DOCUMENT - 2024-346P

**Construction of the Dockstader Peel Region Paramedic Services
Reporting Station**

ADDENDUM 3

A041

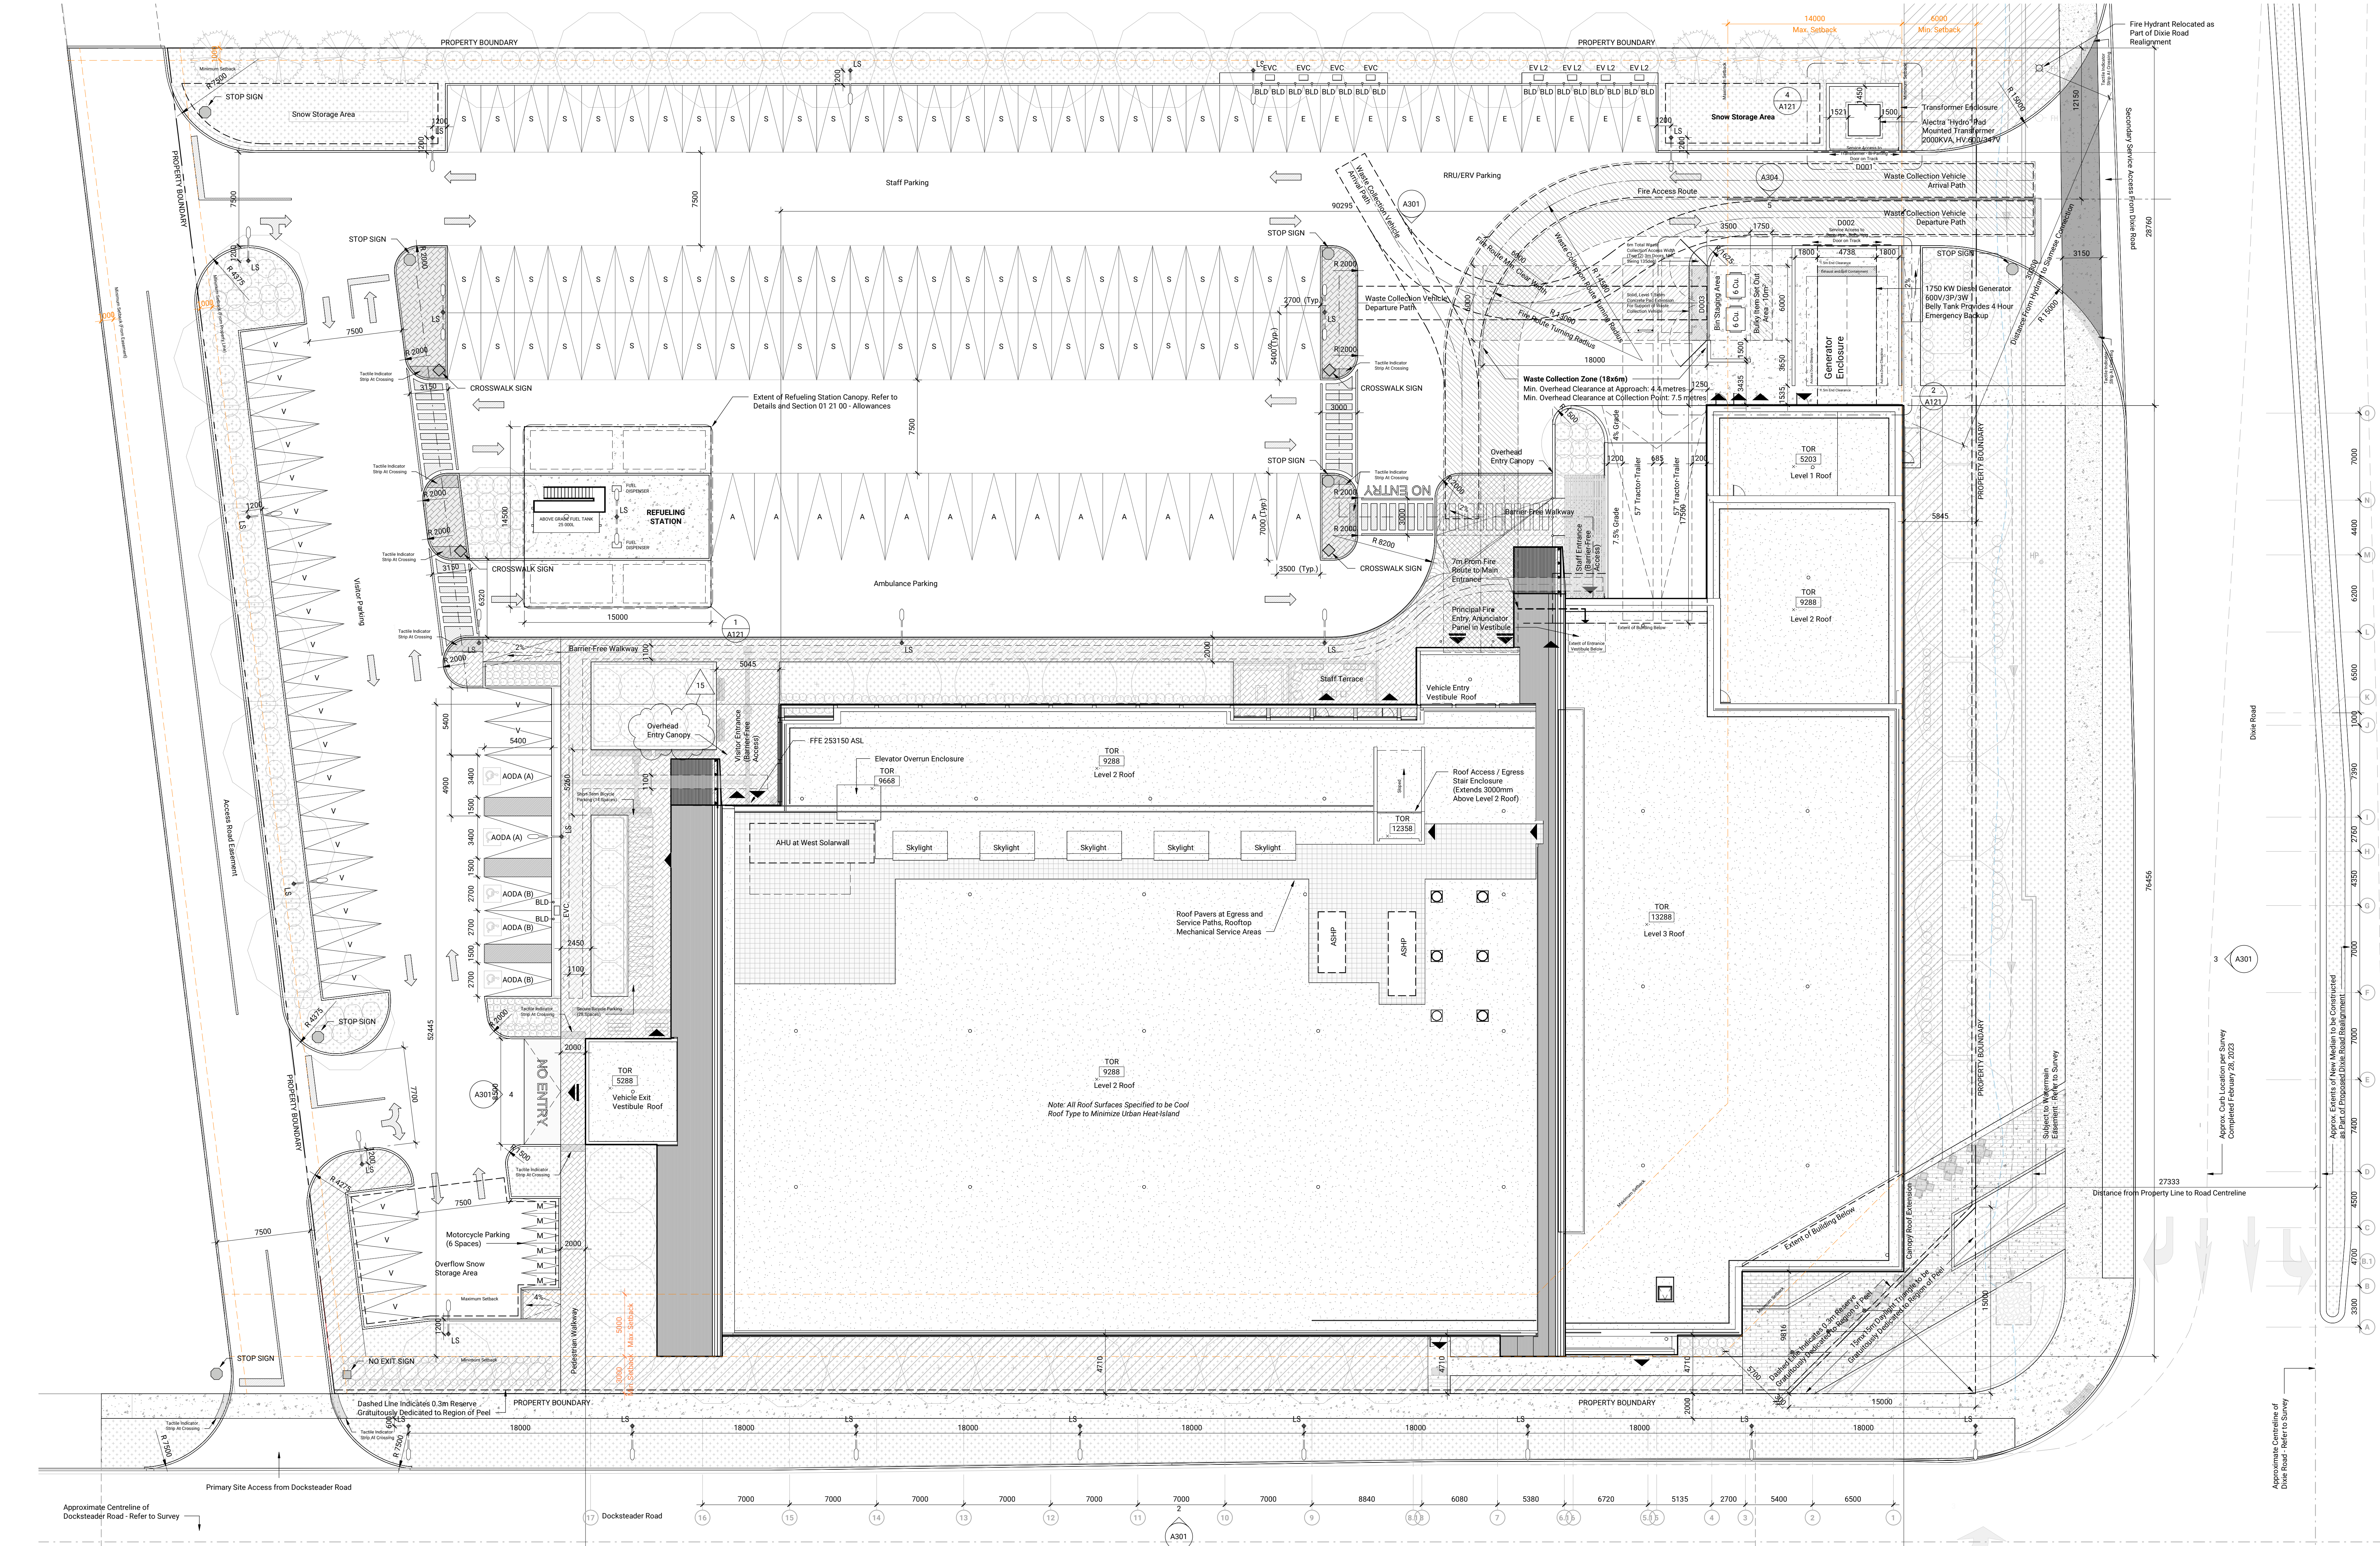
Slab on Grade assemblies shows no concrete topping for SOG1 and 150mm topping for SOG2 on architectural drawing A041, but the structural drawing S201 indicated 125mm topping for SOG1 and 75mm for SOG2 & SOG3. please review and clarify on discrepancies.

Please refer to updated SOG assemblies on drawing A041 issued as part of Tender Addendum No.3. Structural changes will be issued as part of a forthcoming addendum.

Shade Screen Schedule
 As Indicated
A054

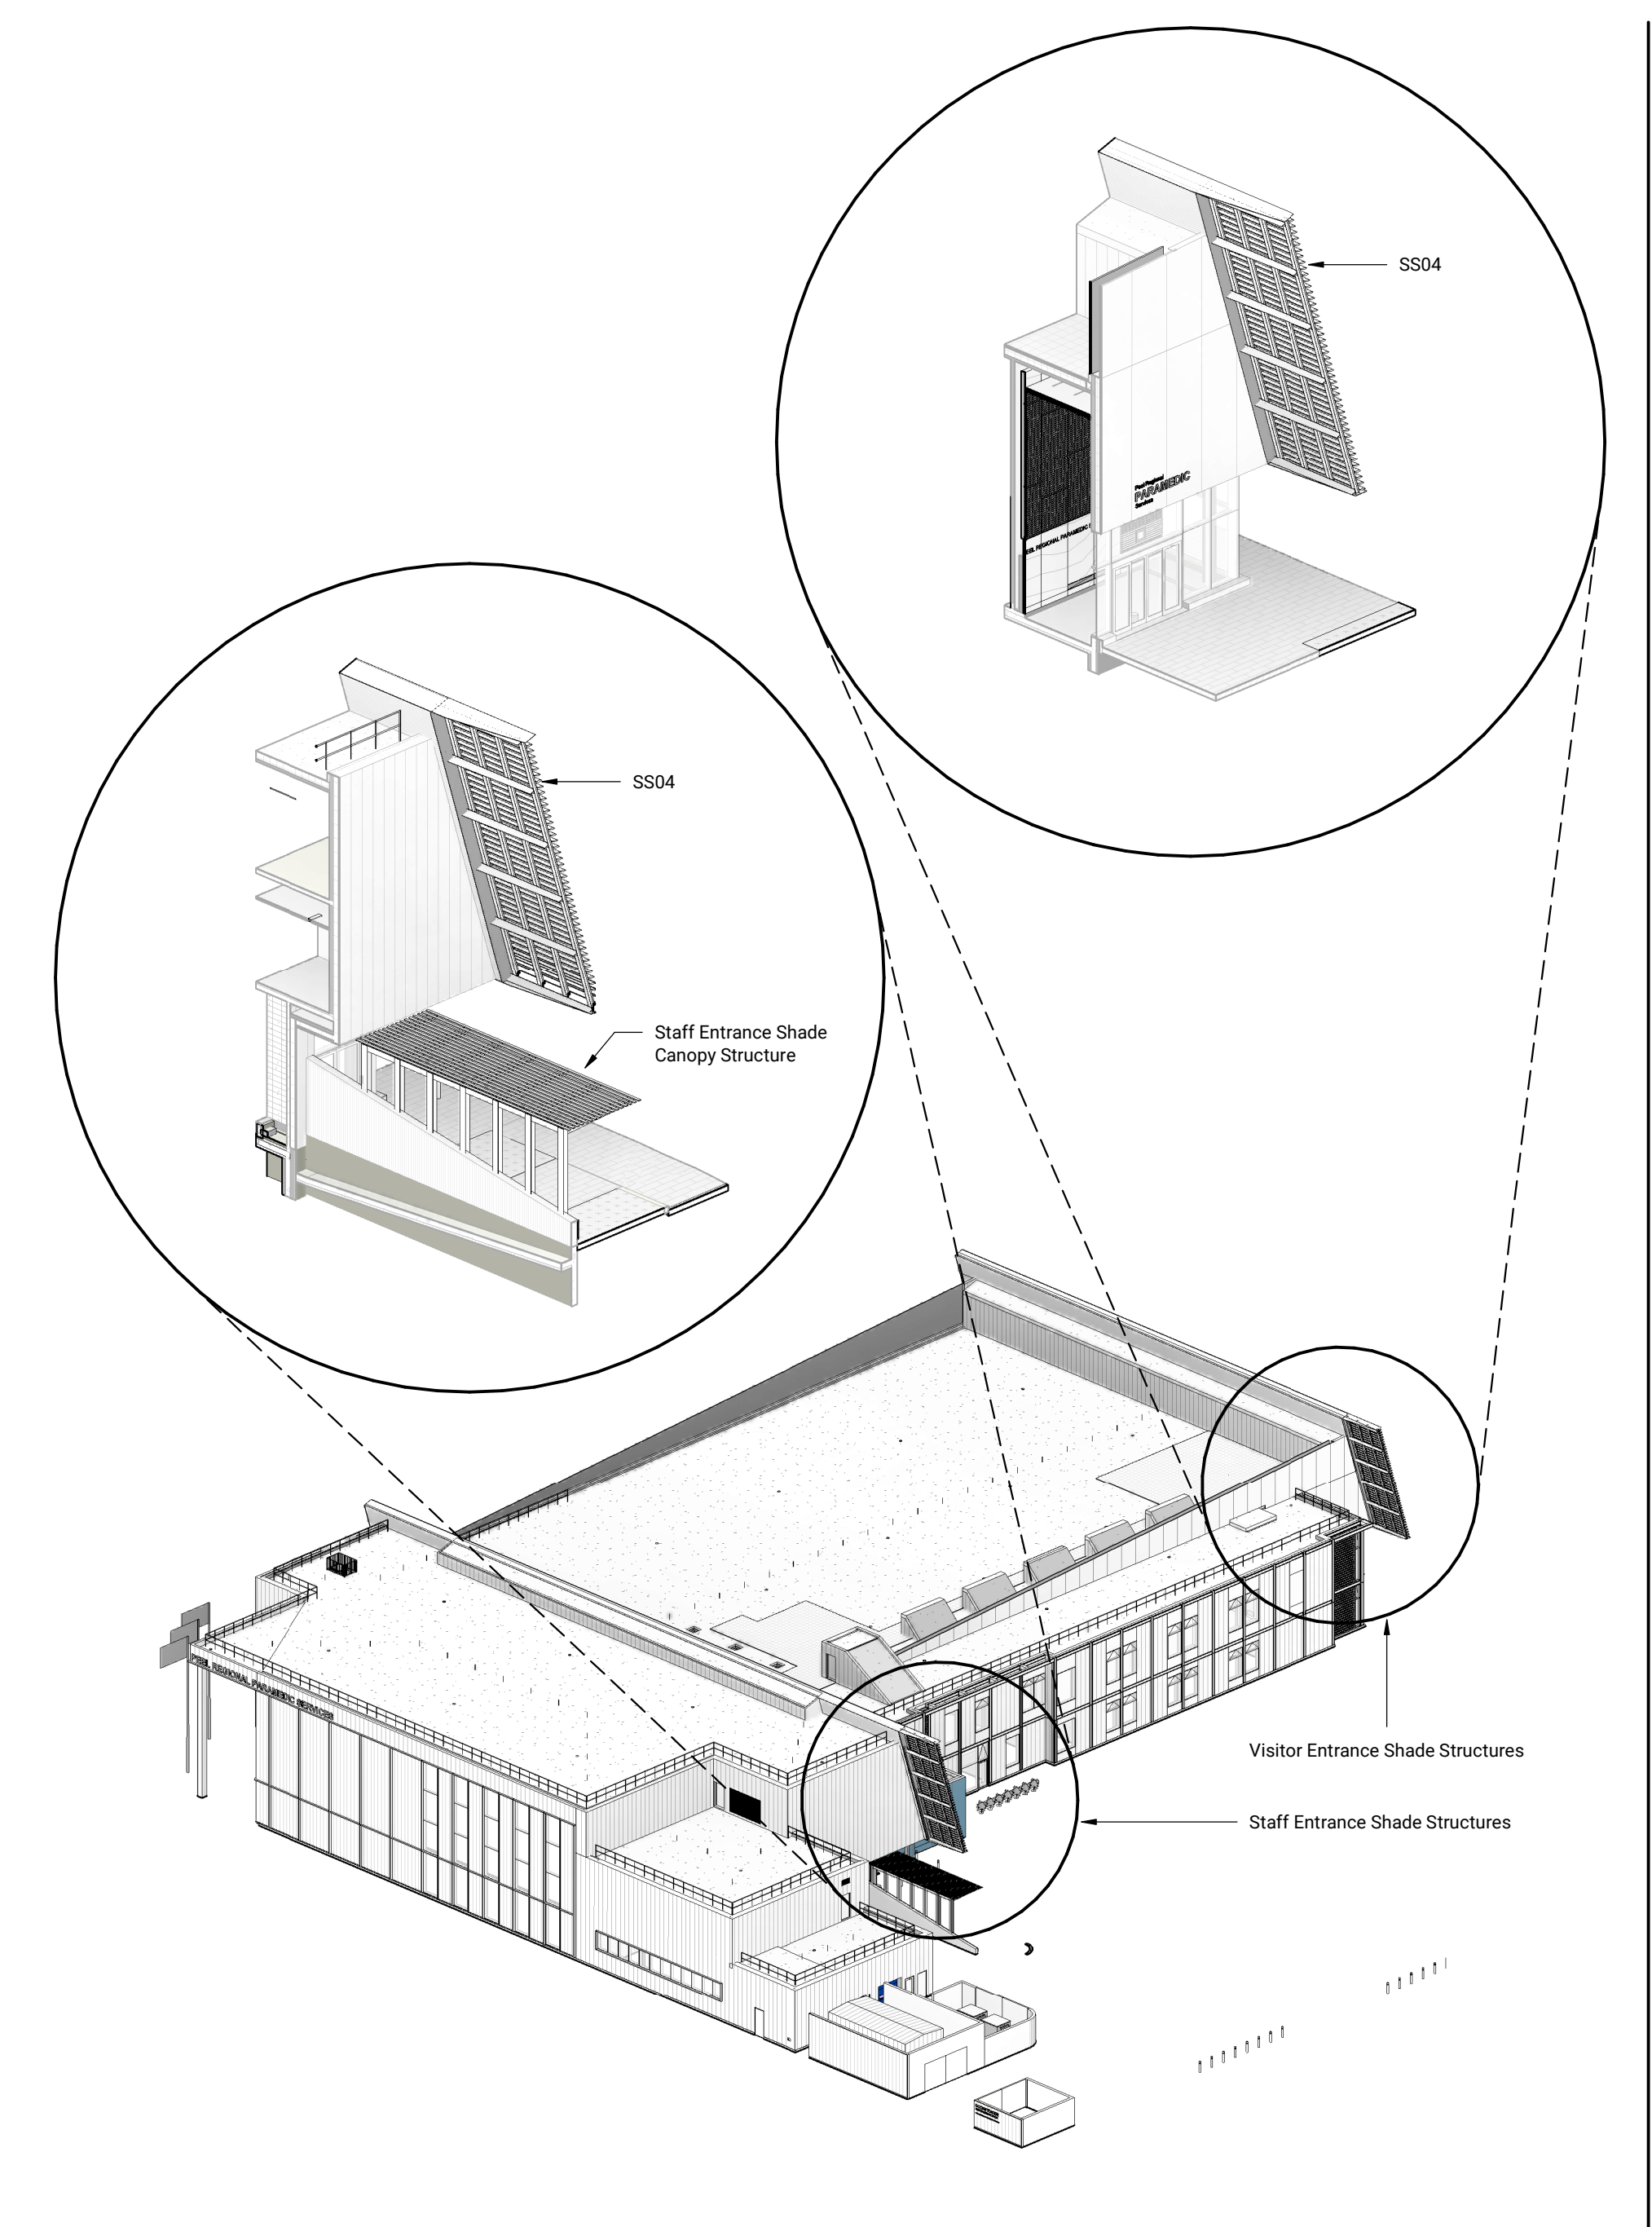
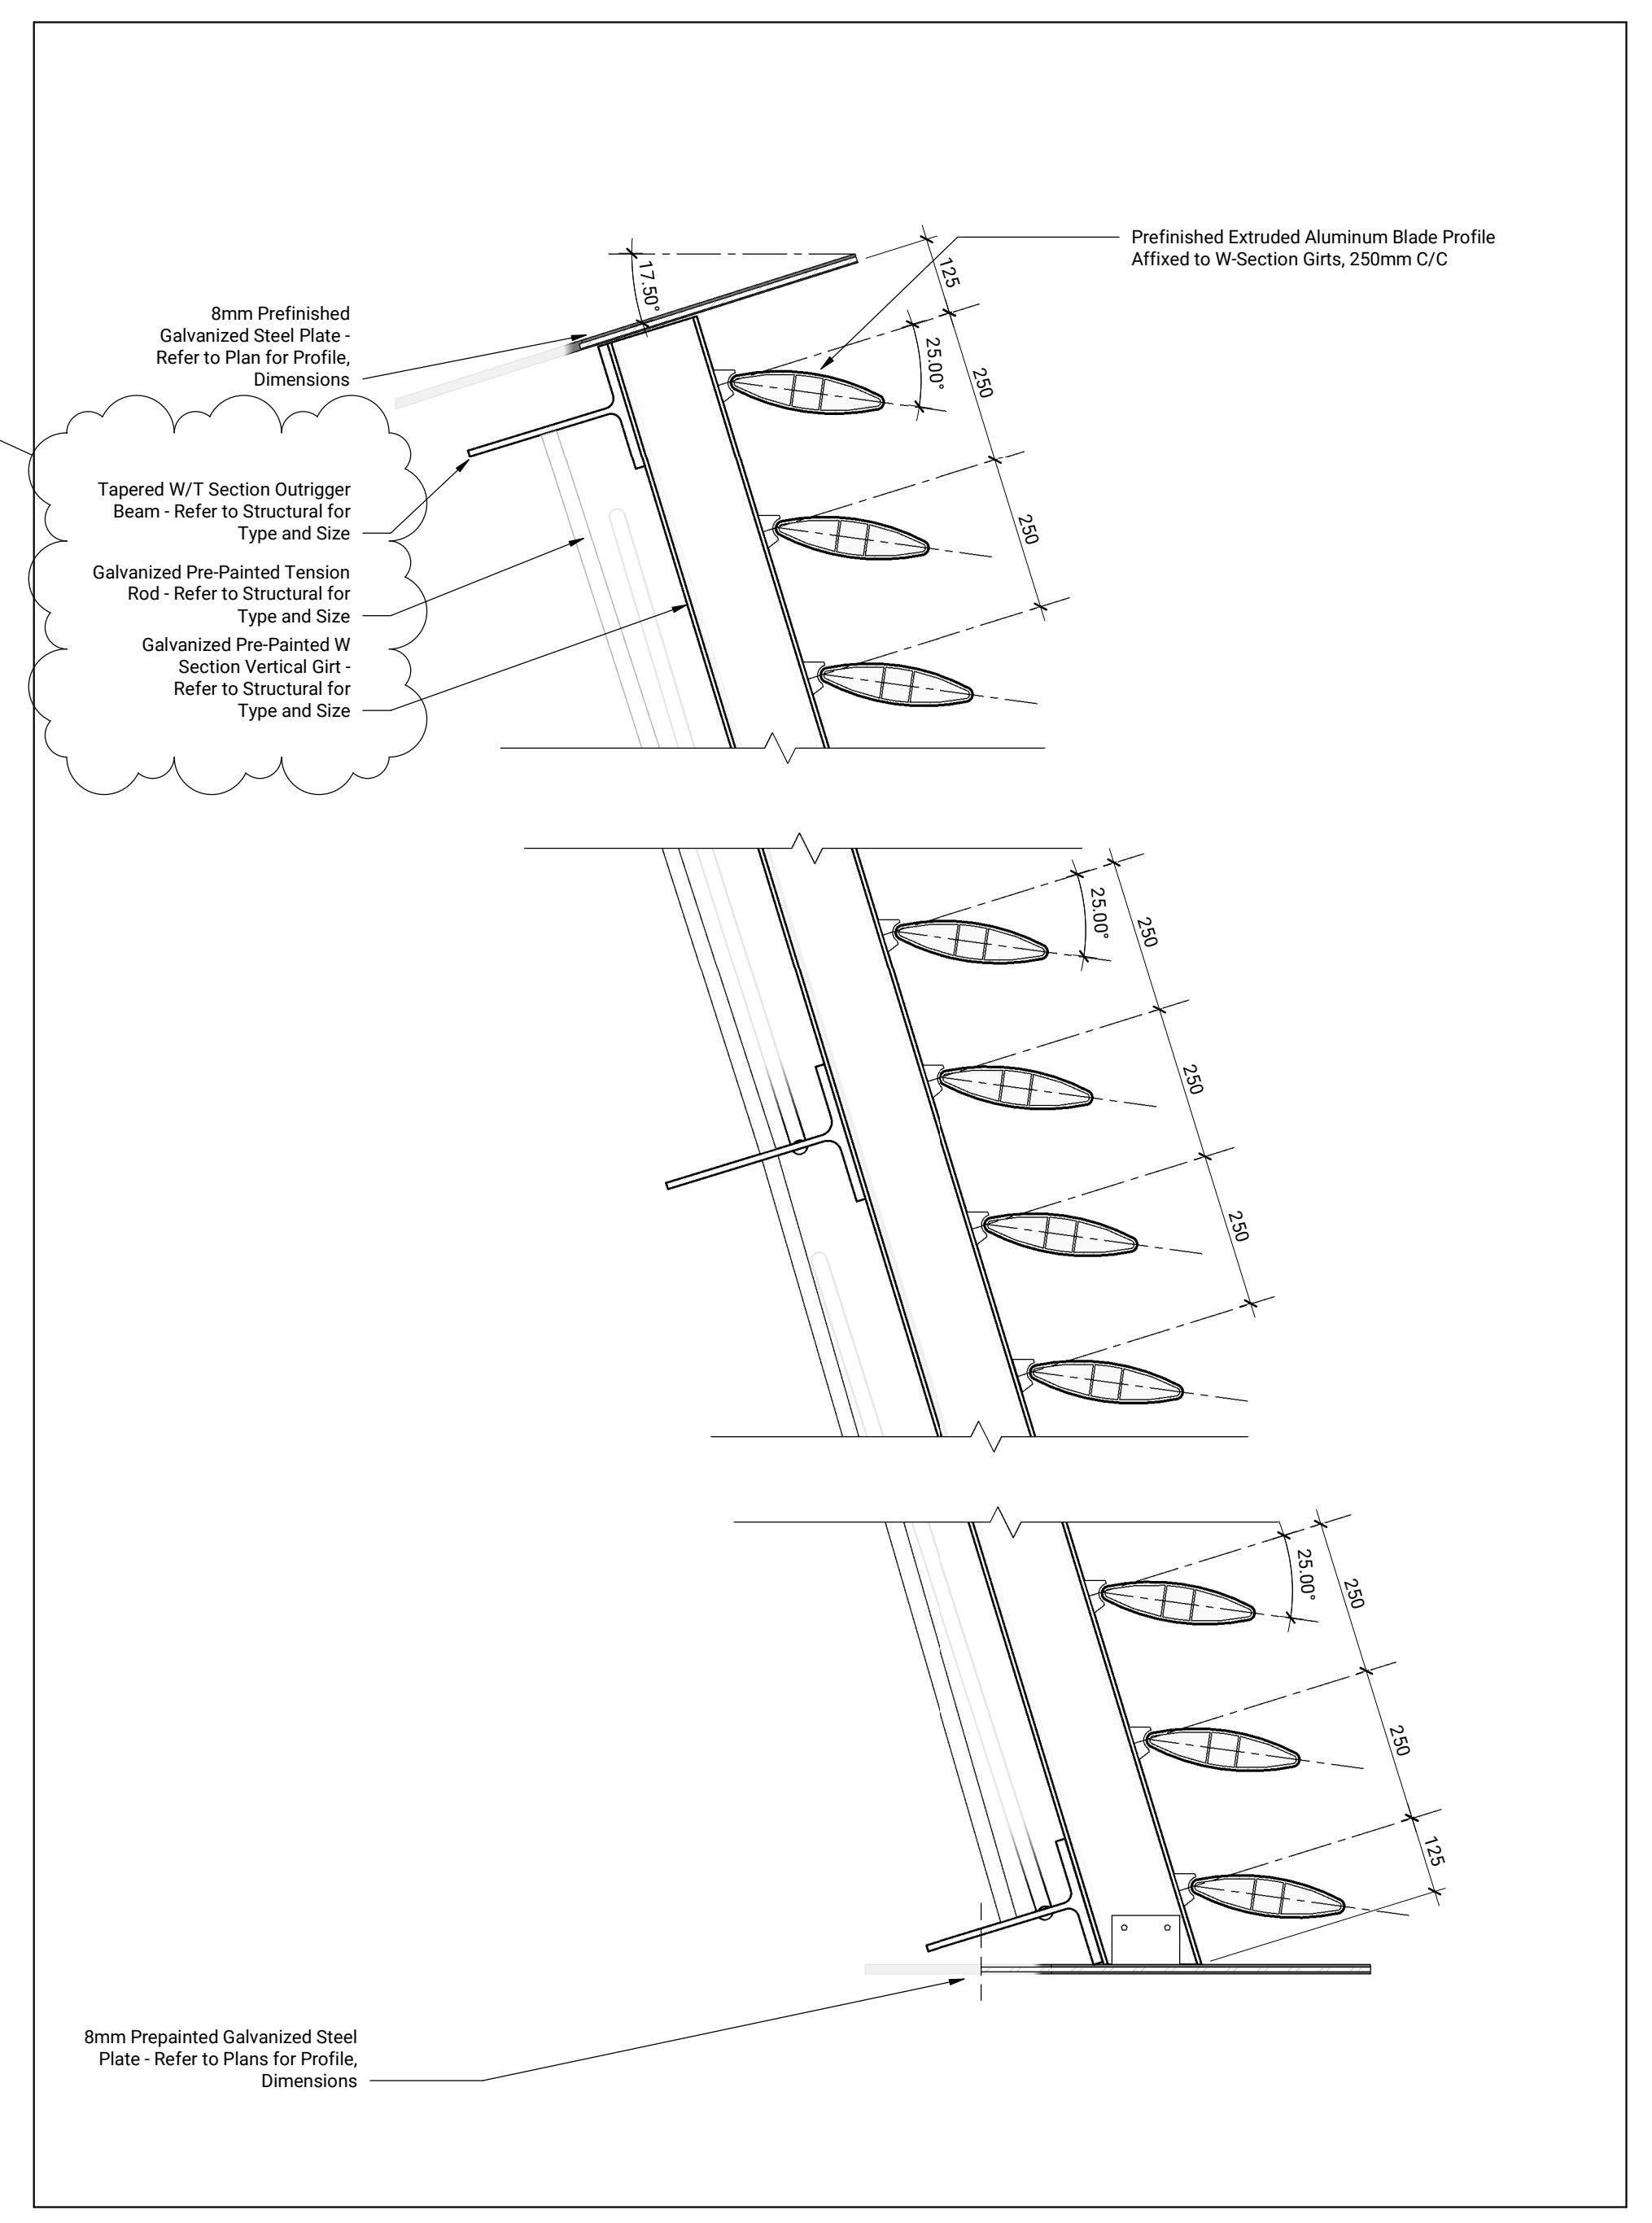
Drawing 4/A054 refers to structural drawing for framing detail of SS04 solar screen wall, but the structural drawings not shown these details. please advise.

Please refer to revised detail 4 on drawing A054 issued as part of Tender Addendum No.3. Note on 4/A054 revised for clarity to "Refer to Structural for Types and Sizing." Framing details to be coordinated through shop drawings after tender award.
